HOKE INCORPORATED

February 2, 1991

SUBJECT: NRC Findings - Appendix B - Notice of Non-Conformance

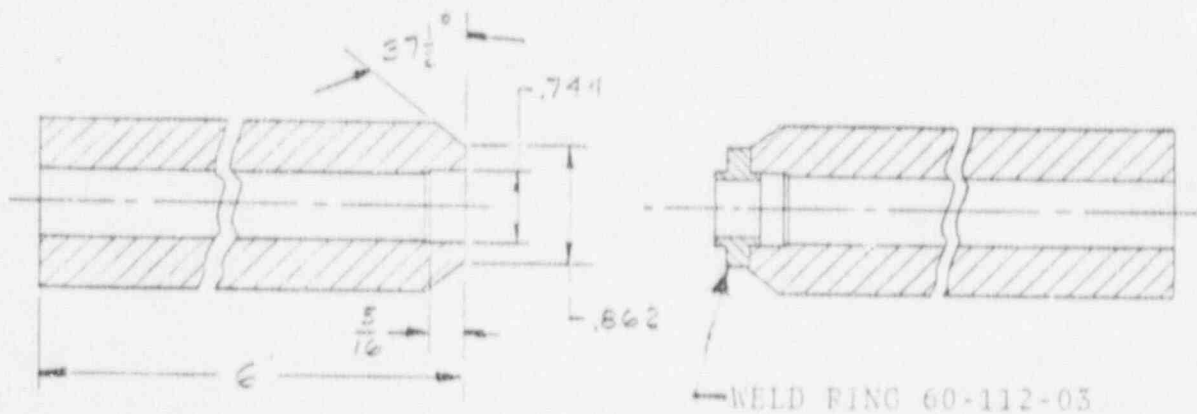
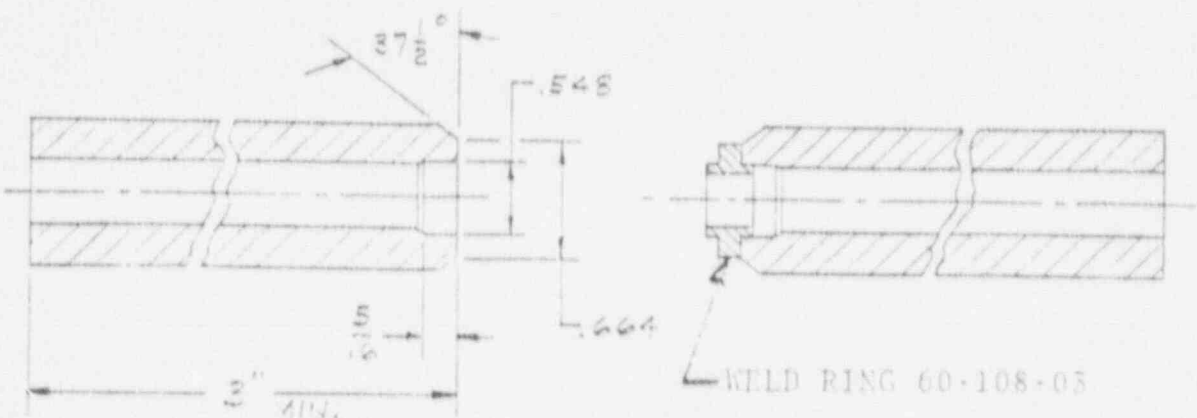
PAGE 3:
Under JOINTS, for Backing Metal add "Base metal: Fillet"
Under BASE METALS, Spec Type, add "or 304 Sst"
For thickness Range, Base metal, Fillet; Delete ".062-.308" & insert "All thicknesses"
For Depositor Work Metal Groove, insert ".062-.308" for Fillet, insert "1/8 min"
For Pipe Dia Range, Groove, insert "1/2 & larger" for Fillet, insert "All diameters"

PAGE 4:
Under POSITIONS, Welding Progression, Vp, add "X"
For Position of Fillet, delete "Forward" and insert "2FR"
Under ELECTRICAL CHARACTERISTICS, Amps, delete "70" & insert "45-120"
For Volts, delete "90" & insert "9-10"
For Tungsten Electrode Size, add ".040"
Under TECHNIQUE, Stringer Work, Bead, add "8 WORK"
For Gas Cup Size, add "1/4"
For other, insert "INSPECTION per HPT-132 unless otherwise specified on traveler or order. PT per HPT-132."

PAGE 5:
Under EXAMINATION, Visual, delete "for proper bead configuration" & insert "per HPT-132, unless otherwise specified"
Under PERFORMANCE, add para c "As allowed by BW-304, one full section tensile specimen shall be welded and radiographed and examined per BW-191 to qualify an additional welding operator"
PAGE 6: Title the 2 figures as Fig. 1 & 2
Add weld ring numbers to the 2 figures.
